**Proposed text of a derogation for the motor tank vessel
“Argos GL” regarding the use of LNG for propulsion**

Decision of the ADN Administrative Committee relating to the motor tank vessel “Argos GL”

Argos Bunkering LNG Fuel System HAZID

HAZID Report

Node 1.1 (LNG Storage Tank) and Node 1.2 (PBU and Vaporiser)

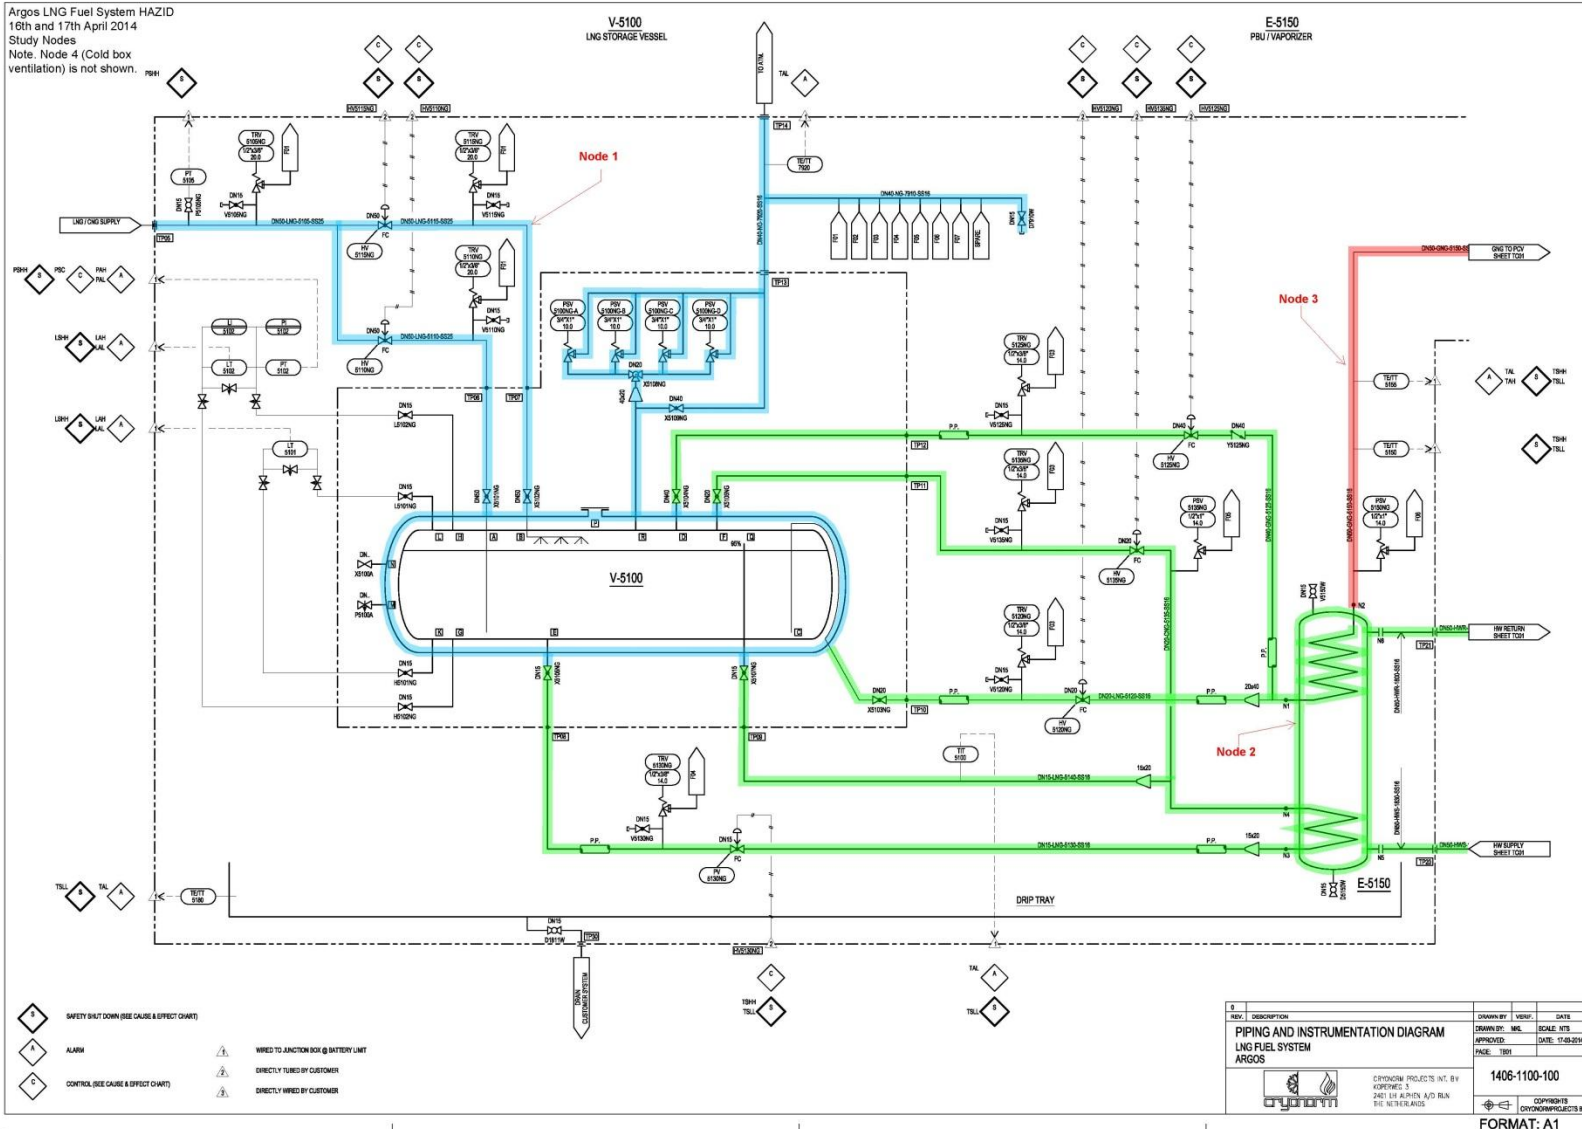
6. Include position sensors on control valves, HV5115NG and HV5110NG.	Consequences: 1.1.1.2.3.1	Cryonorm
7. Treat areas where NG is present as confined spaces and provide the required warnings and procedures.	Consequences: 1.1.2.2.1.1	Argos

8. Check the consequence of immersing the LNG control valve in water - PV5130NG/PV5120NG.	Consequences: 1.1.4.1.2.2	Cryonorm
9. Update P&ID to show extent of the cold box.	Consequences: 1.1.4.1.3.1	Cryonorm

10. Provide details of the bunkering line route and method to ensure that it is empty after bunkering.	Consequences: 1.1.6.1.1.1	Cryonorm
11. Evaluate the consequences of being submerged on the relief valve capacities (including thermal relief valves).	Consequences: 1.1.5.2.2.1	Cryonorm

Node 1.2 (PBU and Vaporiser) and Node 1.3 (Gas Supply to the Engines)

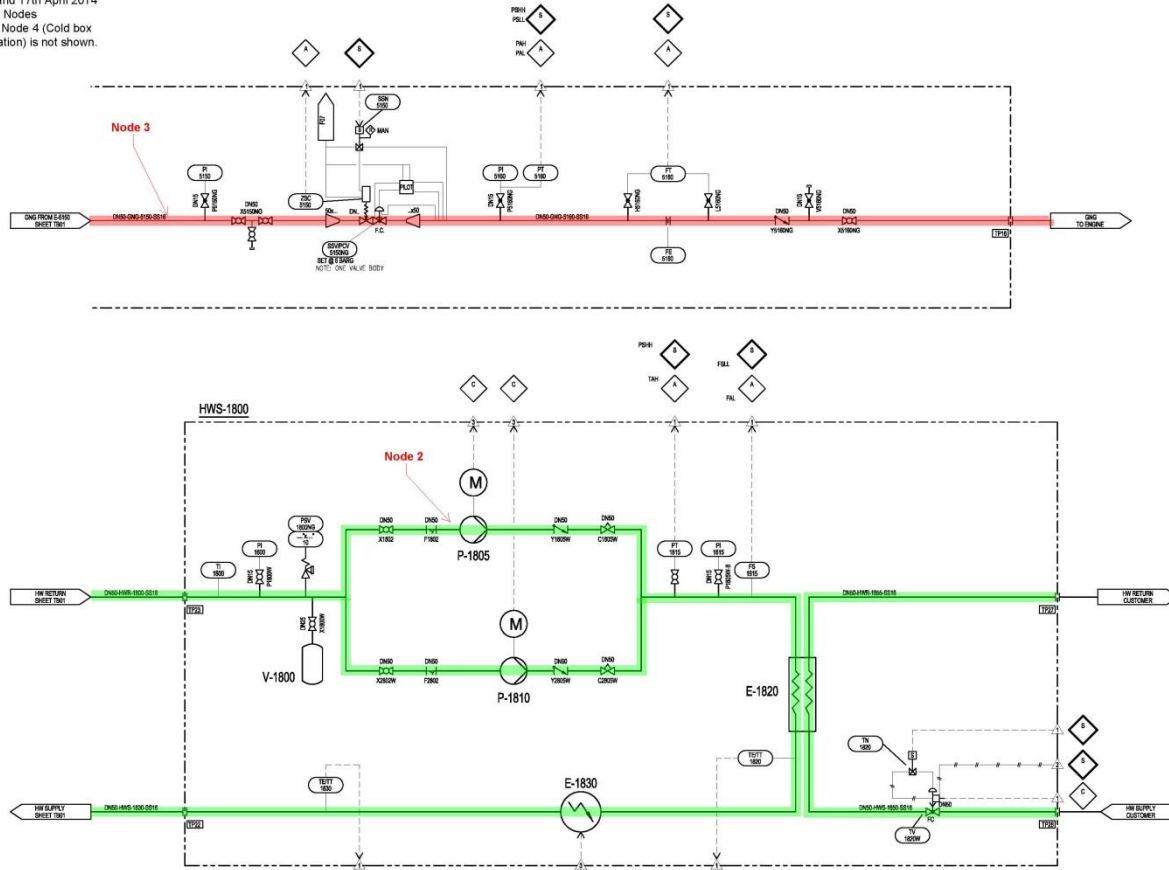
12. Clarify the design of the TRV5185 relief valve, will it protect the engine from overpressure from the high pressure gas supply.	Consequences: 1.3.1.1.1.2	MWM
